**FINAL DRAINAGE REPORT
FOR
HONOR CHARTER SCHOOL
LOCATED AT
8250 BENT GRASS MEADOWS DRIVE
PEYTON, EL PASO COUNTY, CO 80831
PCD FILE NO. PPR2615**

April 2026

3 FOREBAY DETAIL

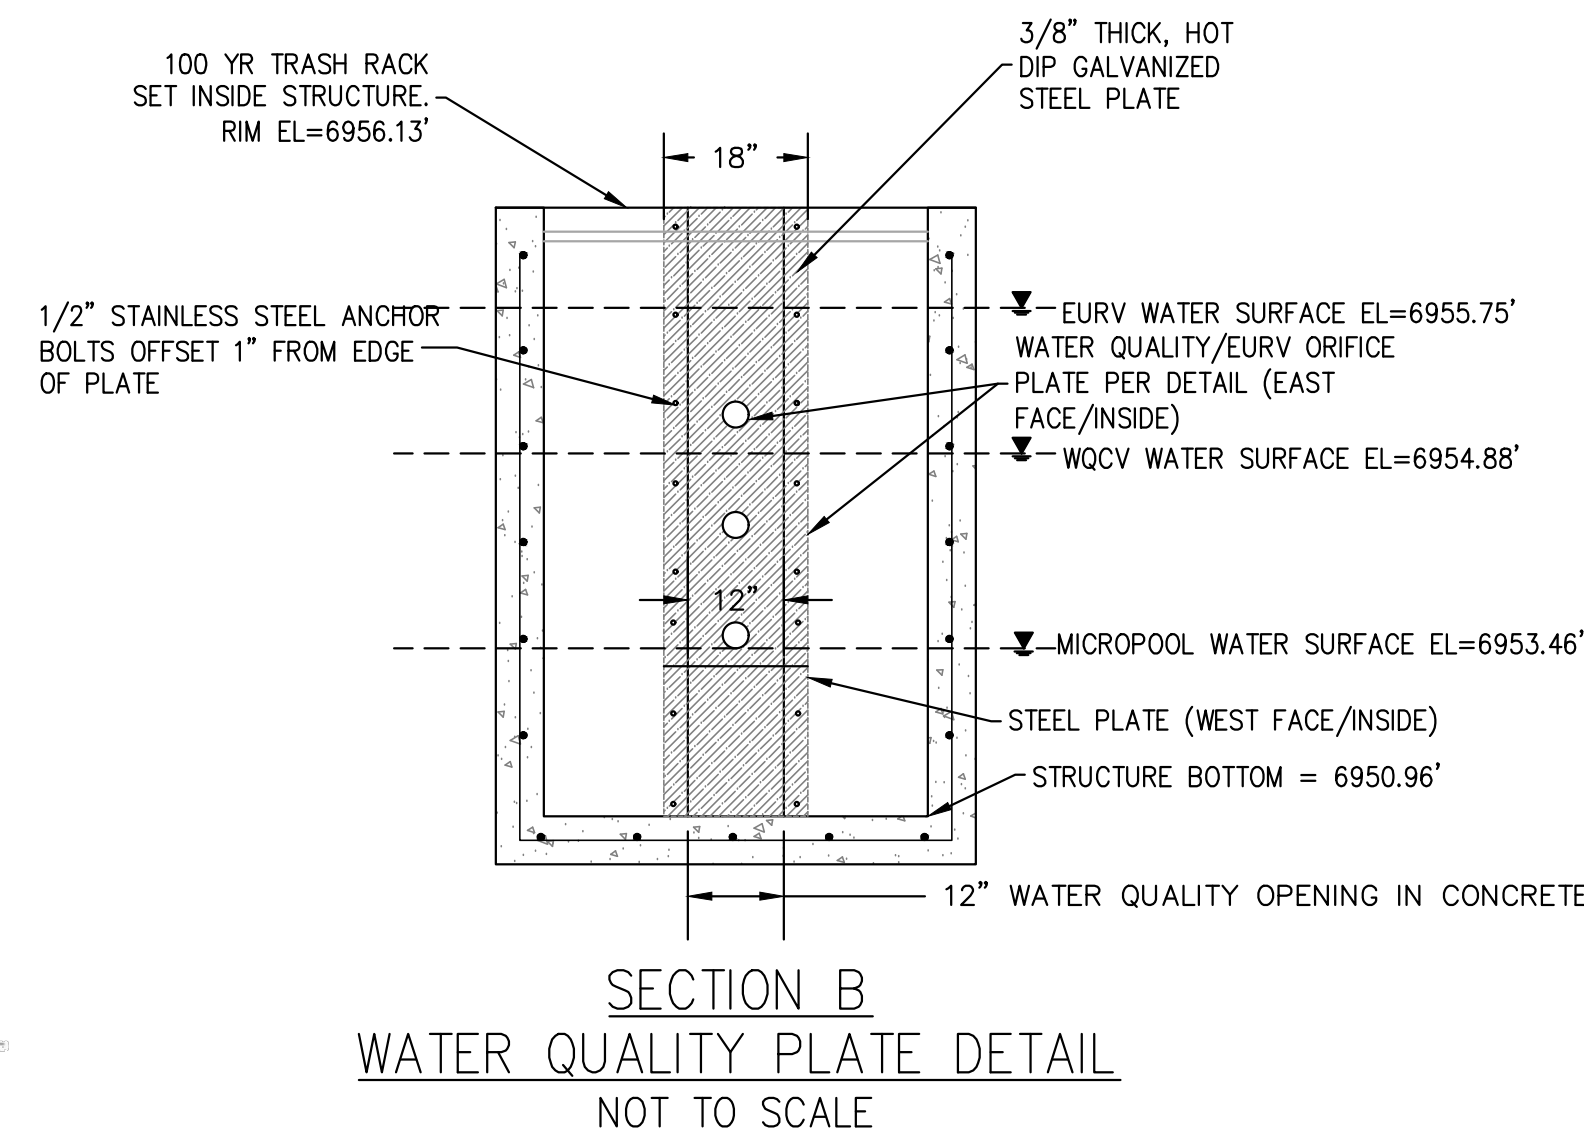
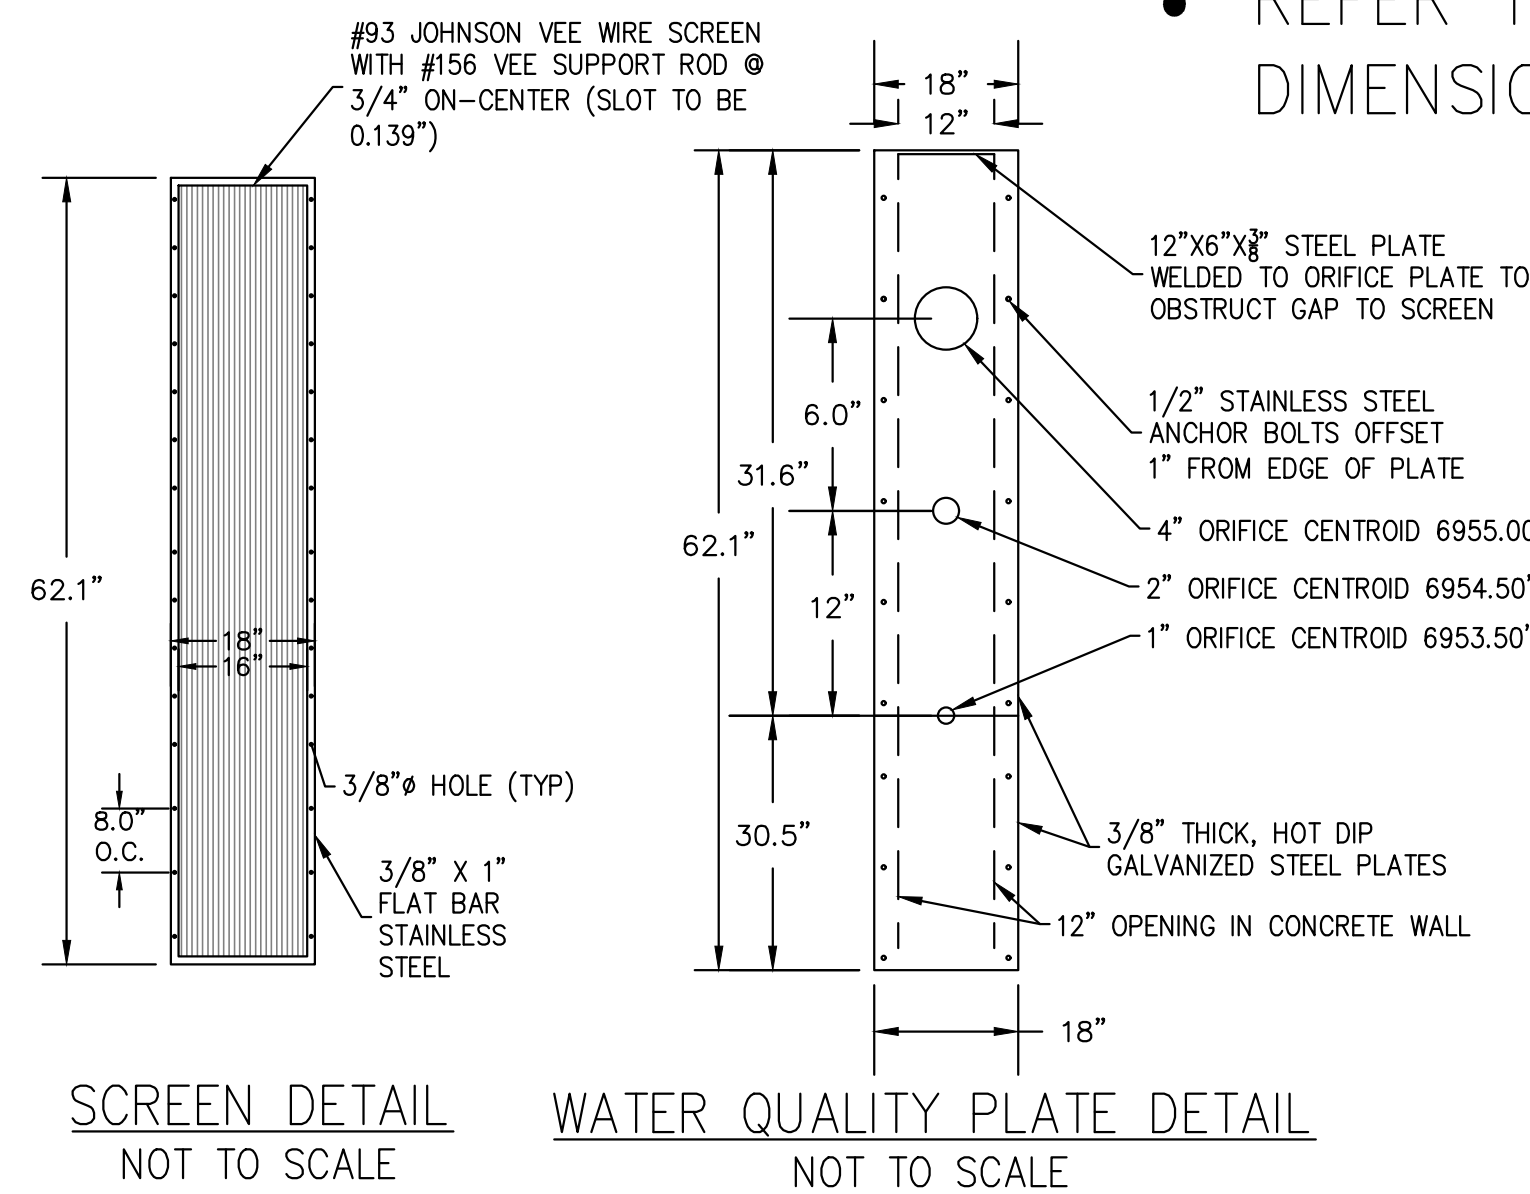
Forebay notch sizes are reversed from what plans specify. Please confirm sizes and revise if necessary.

DETENTION BASIN OUTLET STRUCTURE DESIGN

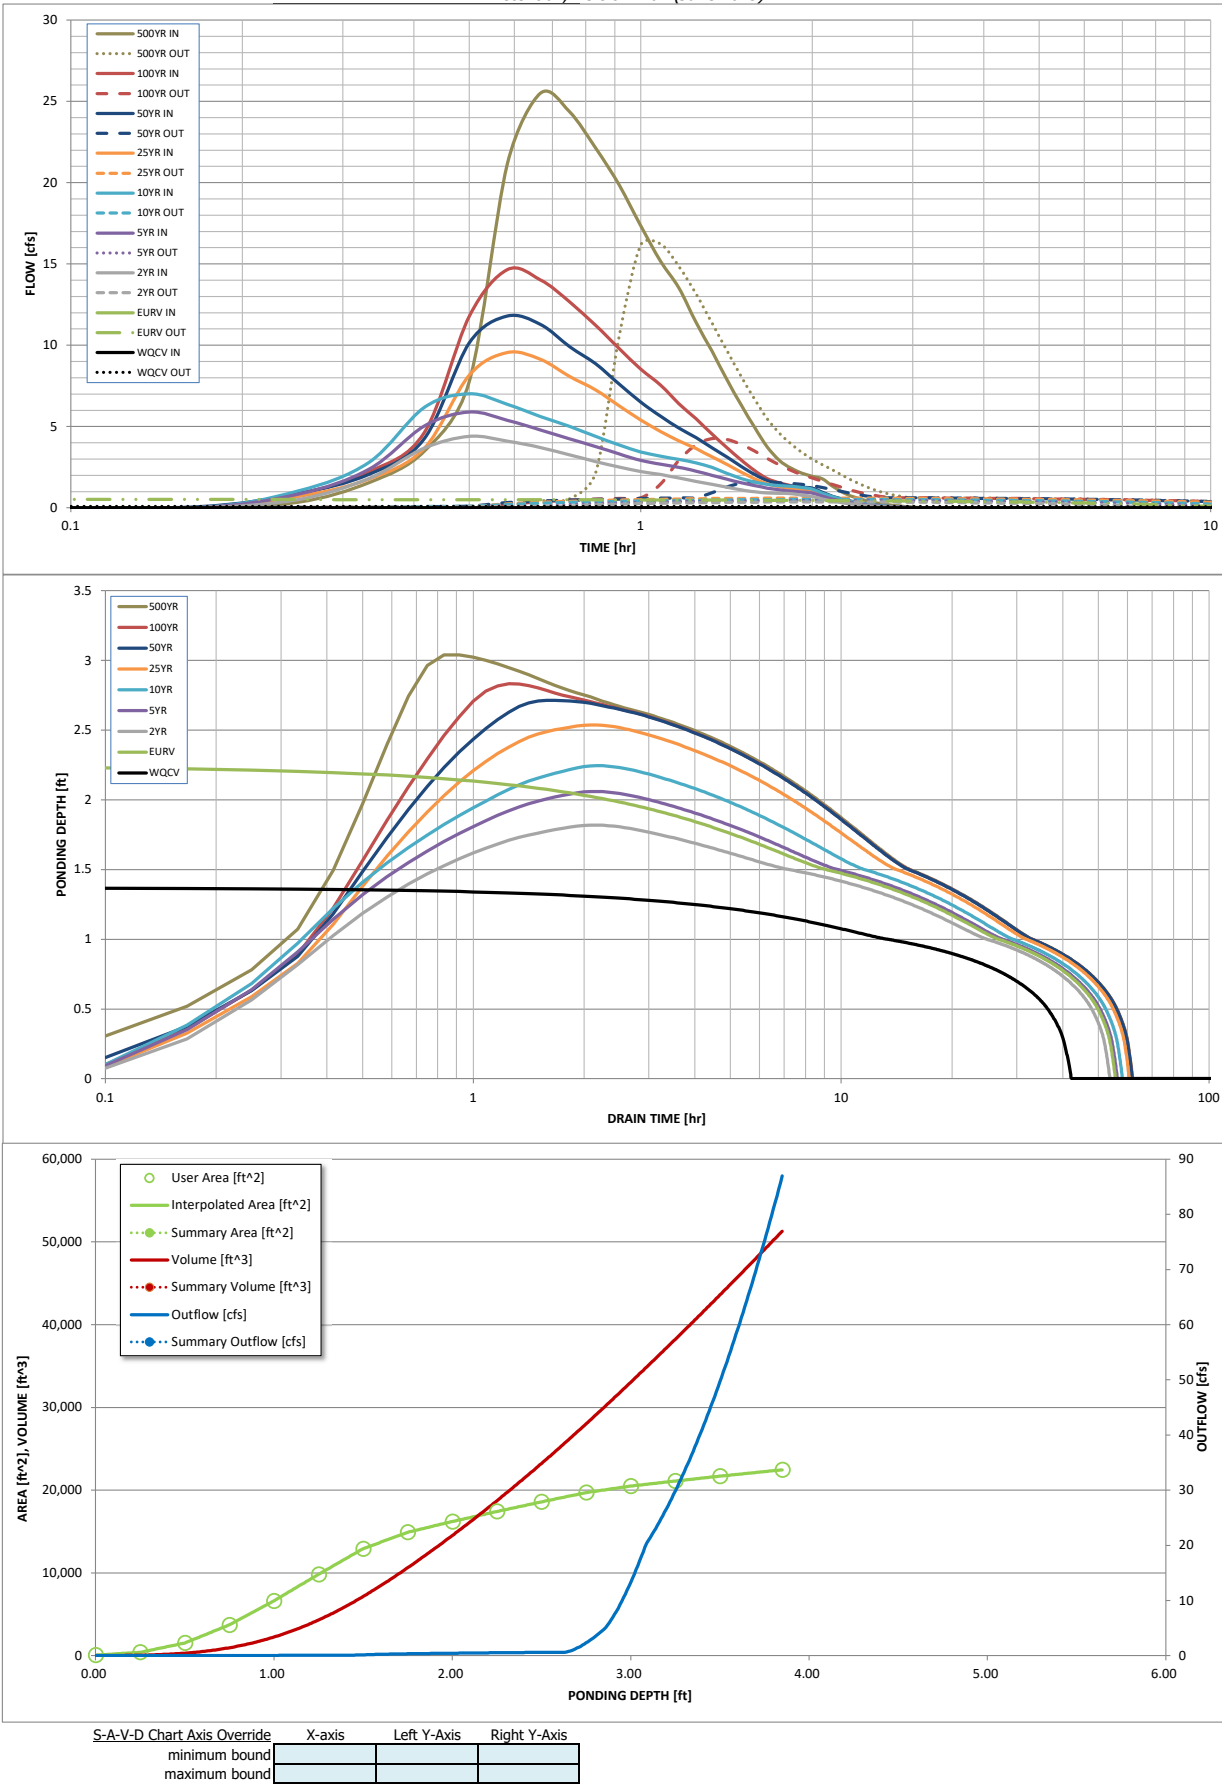
See comment on MHFD Detention calcs

Unresolved: Provide all riprap sizing calculations anywhere riprap is called for (could not locate if added)

X = calcs do not match details in plans

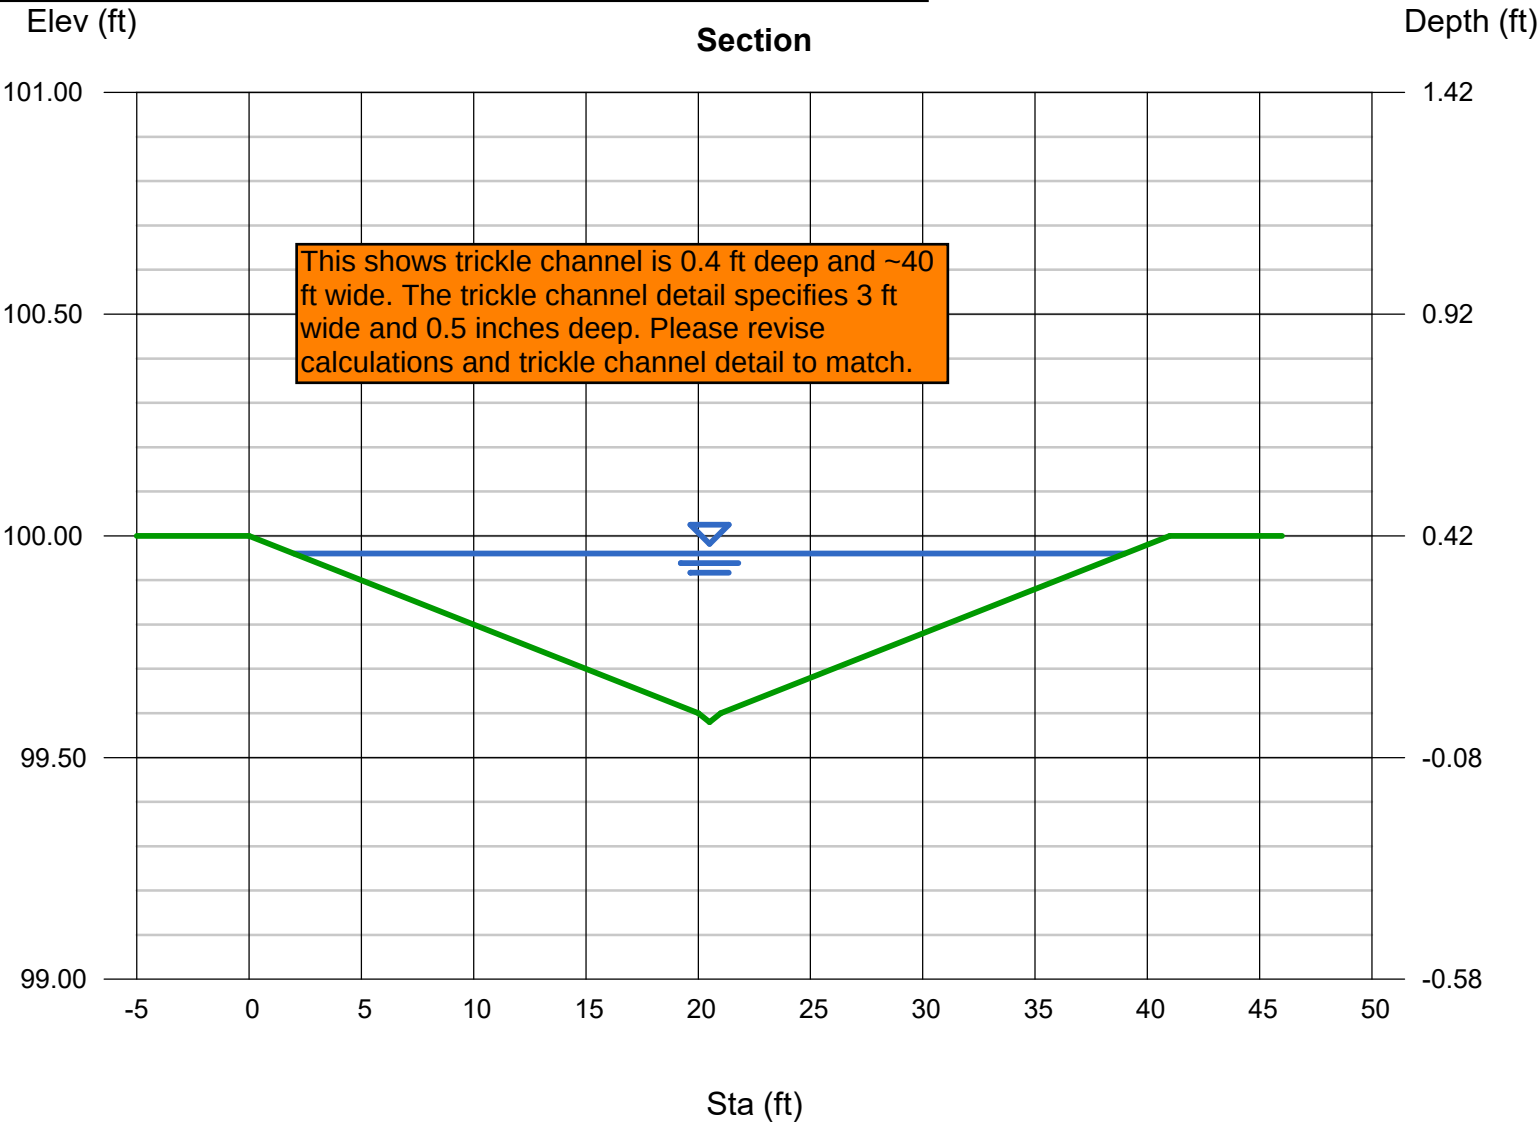
Note: Per DCMv2 – Chap 4.2, trickle channel should at a minimum provide capacity equal to twice the release capacity at the upstream forebay outlet(s).

8.19 cfs satisfies this requirement, just wanted to clarify what was needed.
